Date: April 11, 2022
 To: City Council
 From: Ellen Hardgrove, City Planning Consultant
 Allen Lane, City Engineering Consultant
 XC: Sandy Riffle, Interim City Clerk
 Brett Sollazzo, Administrative Assistant
 Drew Smith, City Attorney
 Re: Proposed Replat of Lots 14 and 15, Block A, Oak Lynn Second Plat, Plat Book W, Page 97

This is a review of a proposed replat of two lots of the Oak Lynn Second Plat: Lots 14 and 15 Block A as recorded in Plat Book W, Page 97, as copied to Exhibit 1. No additional lots are proposed. The proposal is to move the existing line between Lots 14 and 15 to provide existing Lot 14 with lake frontage as shown in Exhibit 2.

Exhibit 2 – Proposed Replat

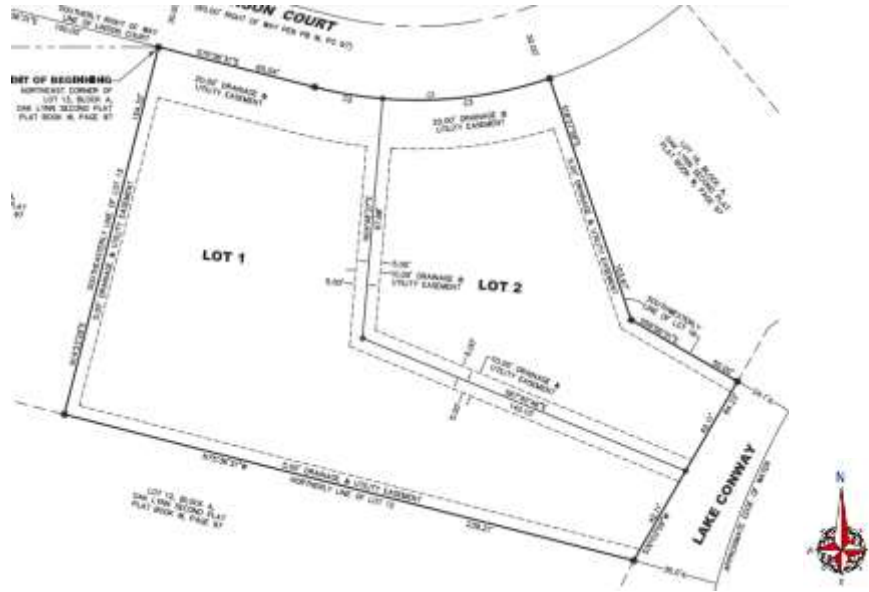
Lot 14 is currently 16,528 square feet and proposed to be, as Lot 1, increased to 23,081 square feet; Lot 15 is currently 19,654 square feet and is proposed to be, as Lot 2, decreased to 13,108 square feet. Both are zoned R1AA. Both new lot configurations meet the R1AA minimum lot area (10,890 square feet).

A house exists on each lot. The proposed new lot line will clip two corners of the house on existing Lot 15 (to become Lot 2), as shown in Exhibit 3. The applicant has stated that the existing house will be demolished if the replat is approved, eliminating a potential nonconforming situation.

There is some question from the applicant as whether the new line for Lot 2 will be treated as a rear or side. In either case, an effective building envelope is created. The applicant’s preference is for Council to make a determination that the new line on Lot 2 will be a “rear lot line” to preserve the lake view from new Lot 1 (Lot 14 of the existing plat).

A couple of minor changes need to be made before recording but do not impact staff’s recommendation for approval. These include a type-over on the survey, and the inclusion of found concrete monuments on the plat (per the survey). In addition, CPH has a concern related to the preservation of drainage flow from Lot 13 (west of the subject property) to Lake Conway. The submitted Boundary Survey, dated March 29, 2022, shows a 10 foot drainage easement from Lot 13 and extending through Lots 14 and 15, east, to Lake Conway. The replat of Lots 14 and 15 to new Lots 1 and 2 shows a 10 foot Drainage and Utility Easement running the full length of new Lot 1 to Lake Conway. One of the General Notes on the plat, Note 3, states “The Drainage and Utility Easement shown hereon is to be owned and maintained by the owners of Lots 1 and 2.” The notes on the new plat do not reference the drainage from Lot 13. As a condition of approval of the new plat for Lots 1 and 2, a note needs to be added to the plat to provide for the allowance of the drainage from Lot 13 through the Drainage and Utility Easement shown on Lot 1.

Approval of the plat as dated Received March 30, 2022 conditioned on prior to recording the plat,

- 1) the minor changes noted by CPH on the survey and plat shall be corrected;
- 2) a note shall be added to the plat to provide for the allowance of the drainage from Lot 13 through the Drainage and Utility Easement shown on Lot 1; and
- 3) the house on new Lot 2 shall be demolished.

In addition, the City recognizes the newly created lot line is a rear yard line of Lot 2 for setback purposes.
